# PREVOST

## WARRANTY BULLETIN

**WB15-14**

DATE :	MAY 2015	SECTION :	04 - Exhaust
EXPIRATION:	MAY 2017		
SUBJECT :	EXHAUST DIFFUSER DRAIN TUBE

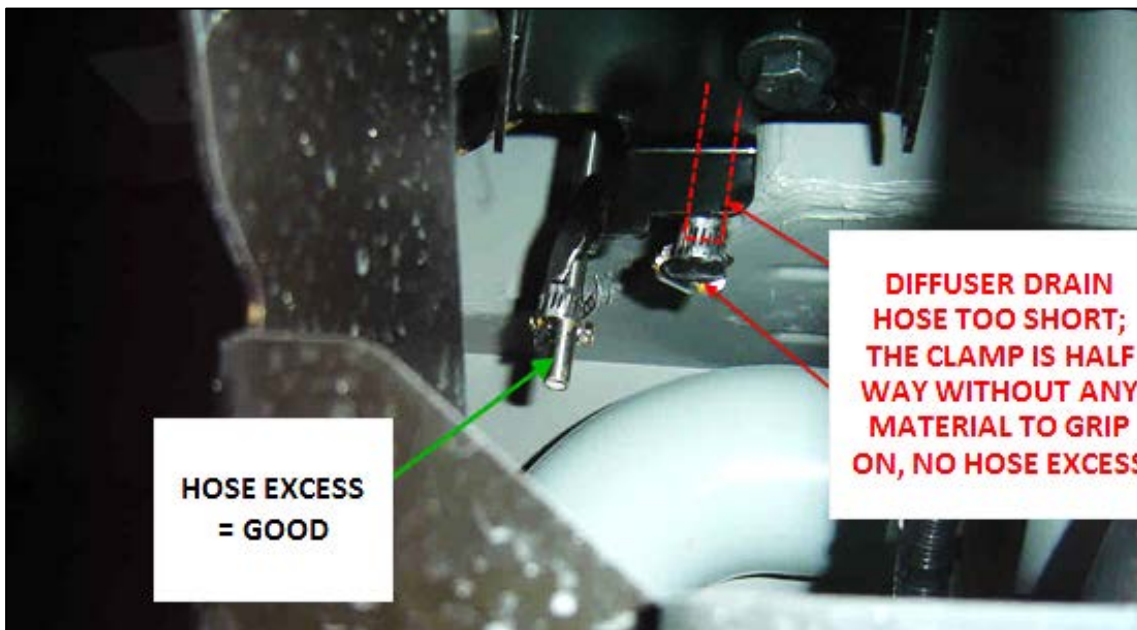
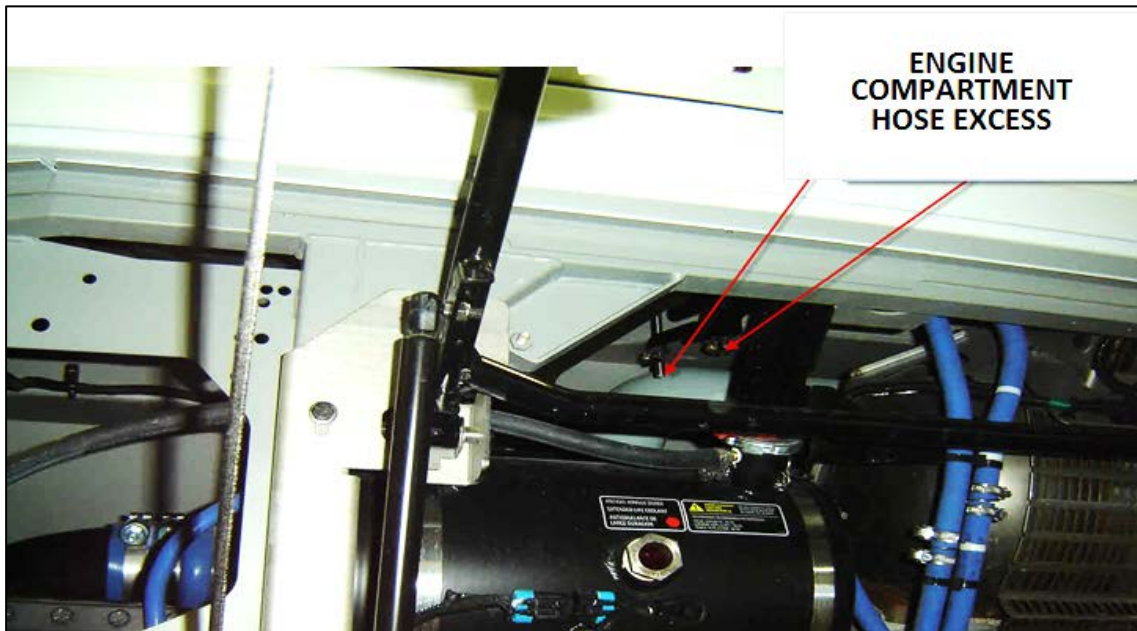
On the vehicles affected by this bulletin, the end of the exhaust diffuser drain tube may not be properly attached.

Part No.	Description	Qty
5011119	ADAPTER / 1/2NPT-Fx1/2NPT-M	1

## PROCEDURE

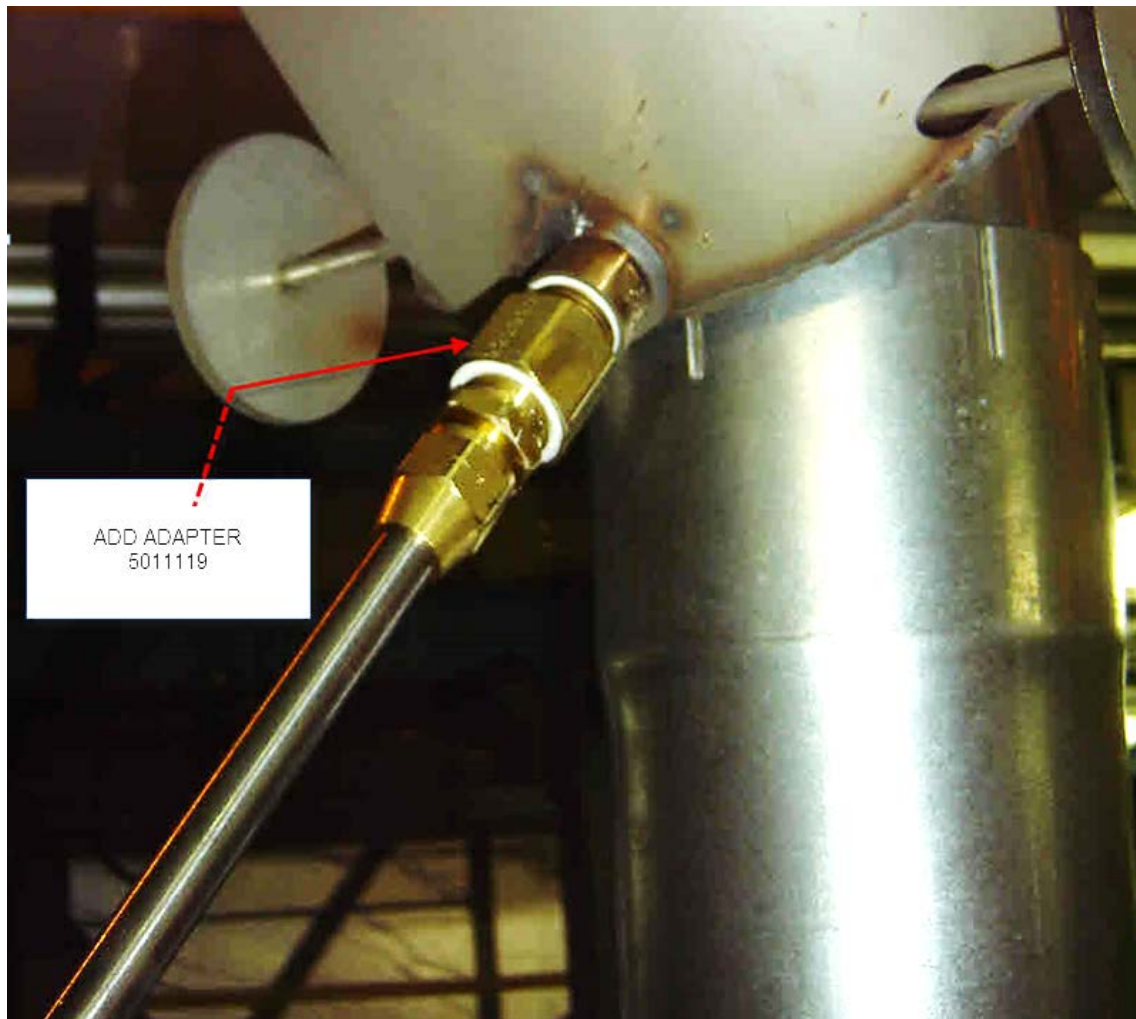
1. In the engine compartment, inspect the lower part of the diffuser drain tube and make sure there is an excess length allowing proper seating of the clamp.
2. If it is not the case, unscrew the clamp to free the tube.

3. Add adapter #5011119 to the upper connexion.
4. Re-tighten lower clamp.
